STATE OF WASHINGTON
DEPARTMENT OF ECOLOGY

October 6, 2015

Re: Opinion on Proposed Cleanup of the following Site:

- **Site Name:** Woodworth & Co. Lakeview Plant
- **Site Address:** 2800 104th Street South, Tacoma
- **Facility/Site No.:** 1372
- **Cleanup Site No.:** 165
- **VCP Project No.:** SW1012

FIGURE 3

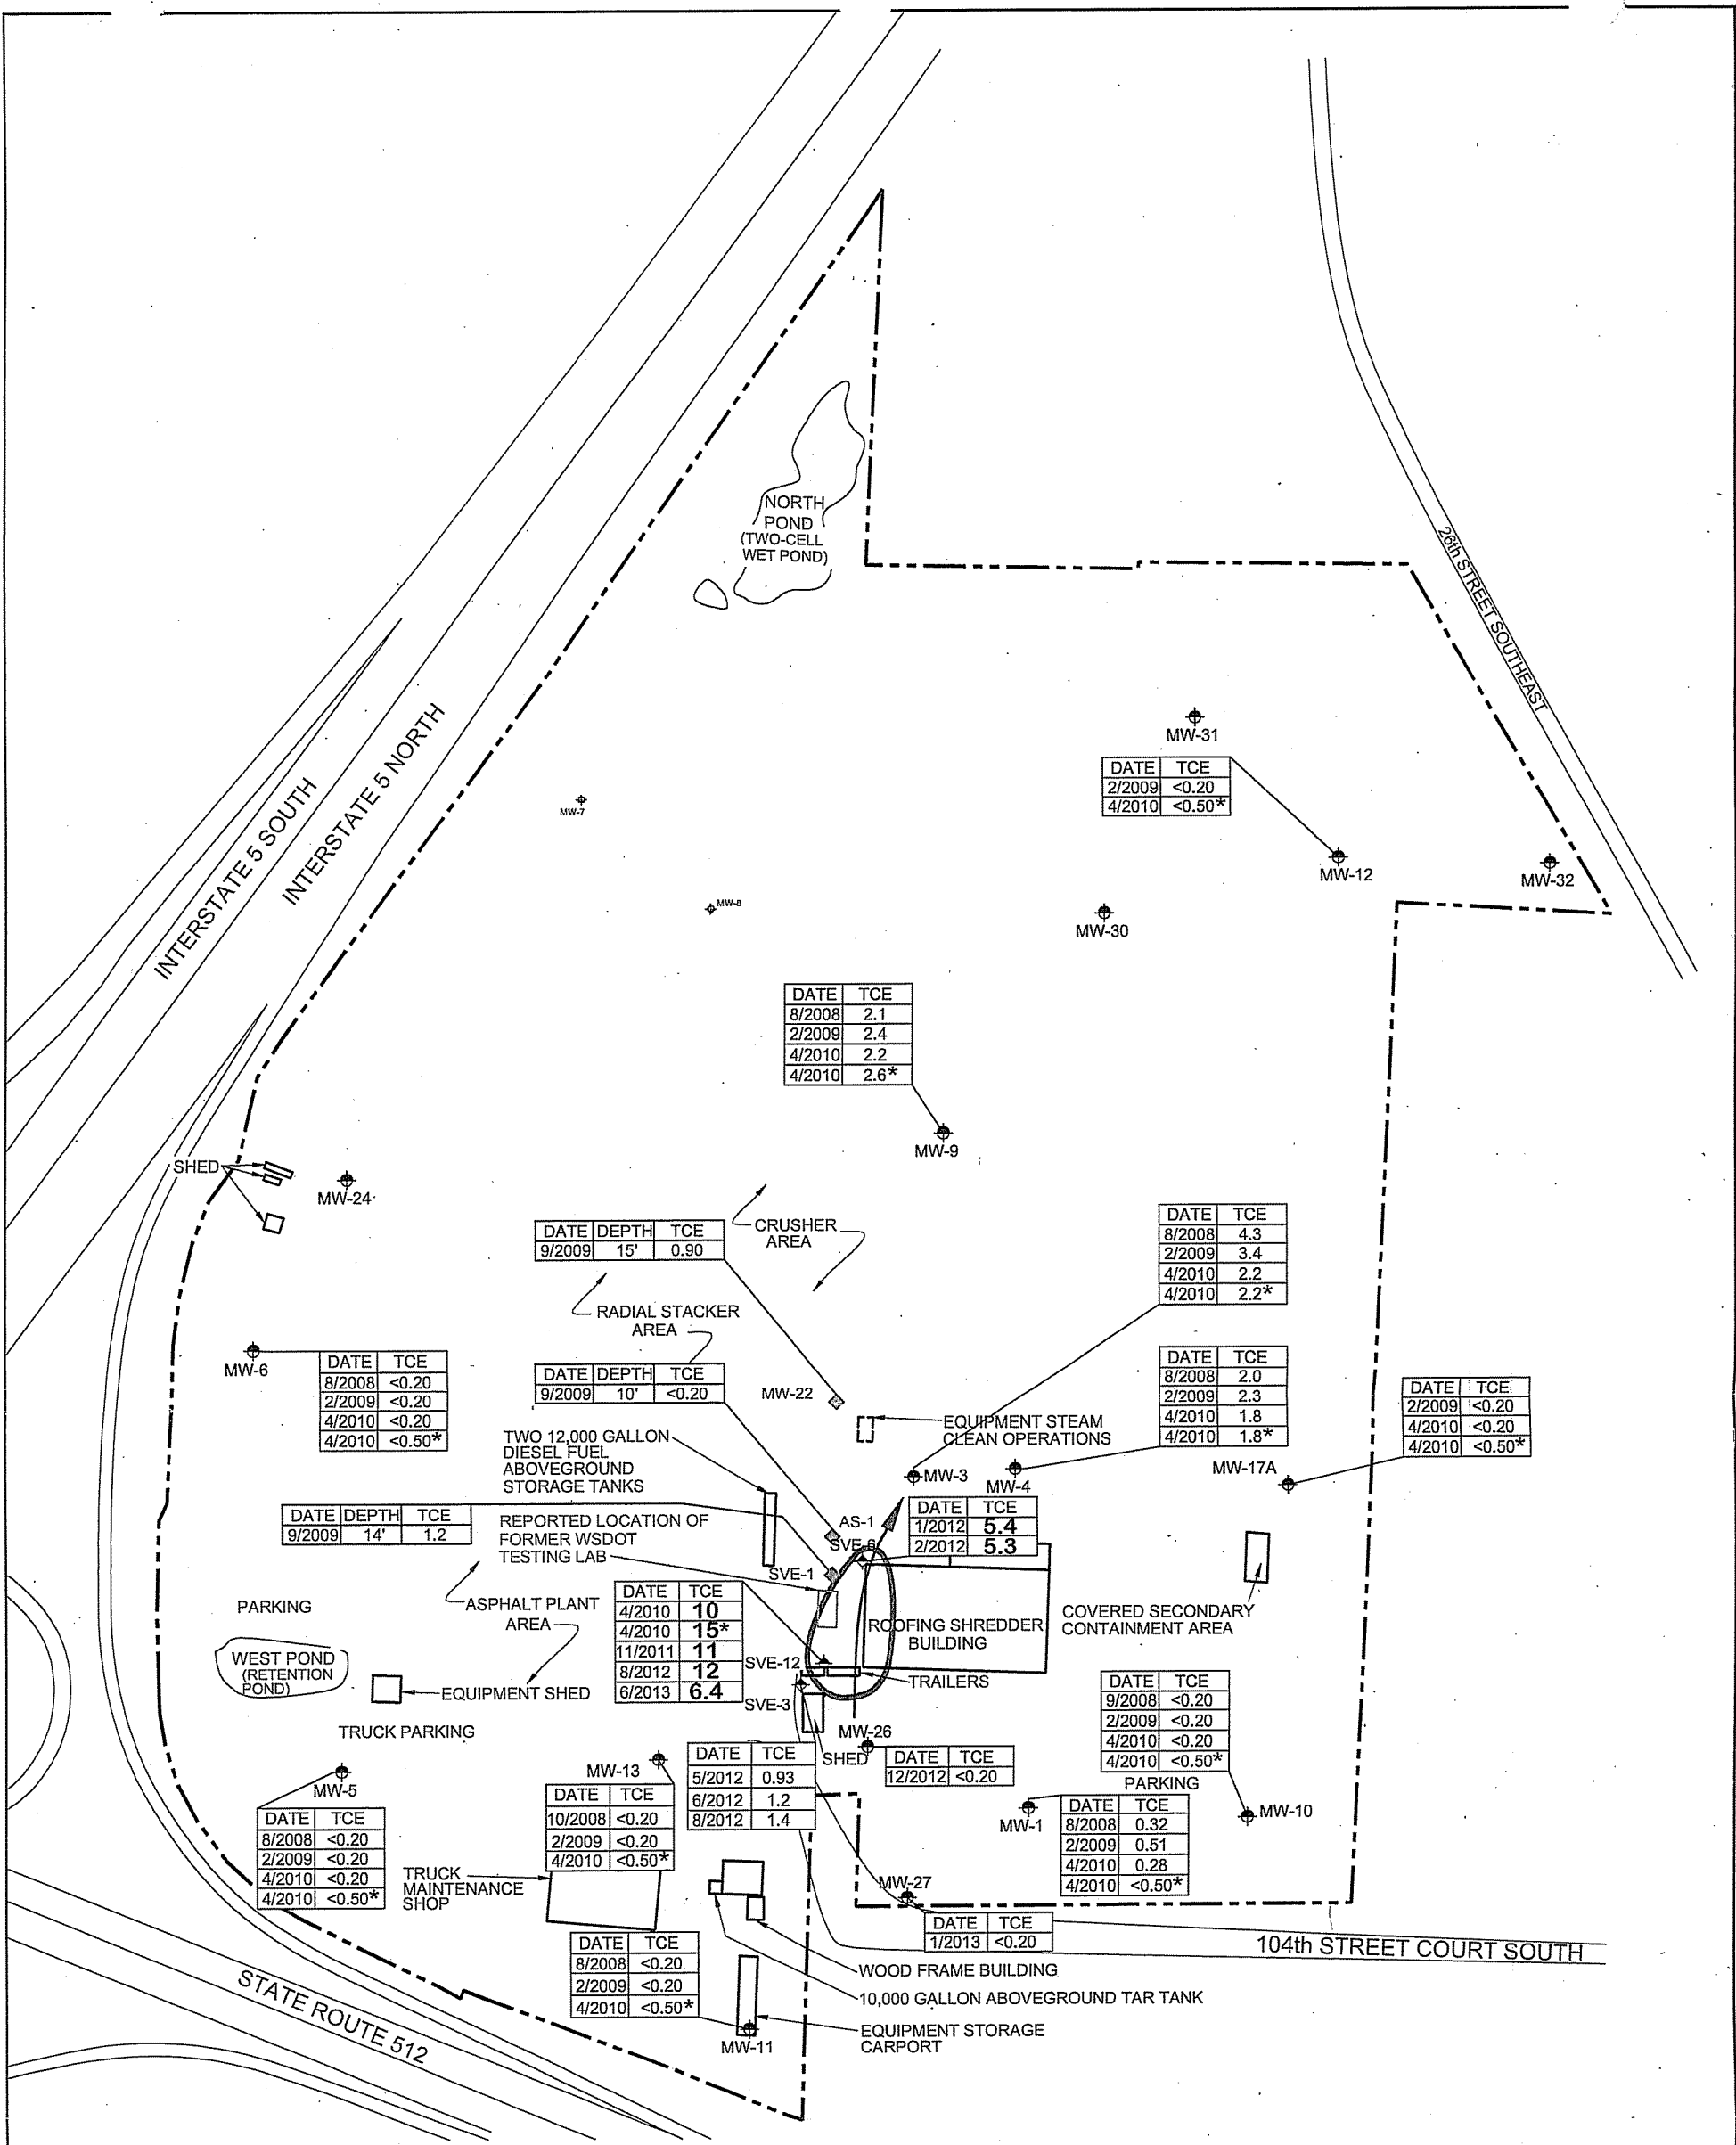
Further subsurface investigations in AOC 4 were conducted by Farallon between July 2012 and January 2013; including the advancement of seven soil borings, as well as five monitoring wells (MWs). According to Figure 6, the borings (B-2 to B-7 and B-9) advanced to characterize soil in AOC 4 were located generally to the south of the presumed former DOT testing laboratory, not within, immediately adjacent to, or surrounding the presumed DOT laboratory location. In addition, the April 2015 report indicates the soil sample data for AOC 4 is present in Table 3, however, the title of the aforementioned table references AOC 5, which is misleading. In the soil samples collected to the south of the presumed DOT laboratory location, TCE or its associated degradation constituents were not detected at concentrations at or exceeding the laboratory PQLs or MTCA Method A CULs in soil. TCE-impacted shallow and deep groundwater zones in AOC 4 are illustrated in Figures 3 and 4, respectively.

2. The current AOC 4 Alternative 1 (ICs) does not meet the substantive requirements of MTCA. This alternative relies on dilution and dispersion for cleanup. Ecology does not agree that sufficient source area characterization has been conducted or considered enough remedial alternatives to justify the choice of dilution and dispersion as a remedy.

AOC 4 Alternative 1 is also unacceptable because the Site will not meet groundwater CULs within a reasonable restoration timeframe. The Feasibility Study (FS) assumes that TCE concentrations will continue to decline along the trend observed during AS/SVE operation. This assumption is unrealistic and likely incorrect. Ecology expects concentrations to increase upon SVE shutdown unless source area TCE removal or reduction is part of the remedy. Additionally, MWs in AOC 4 have not been sampled since June 2013. We recommend resampling these wells to determine
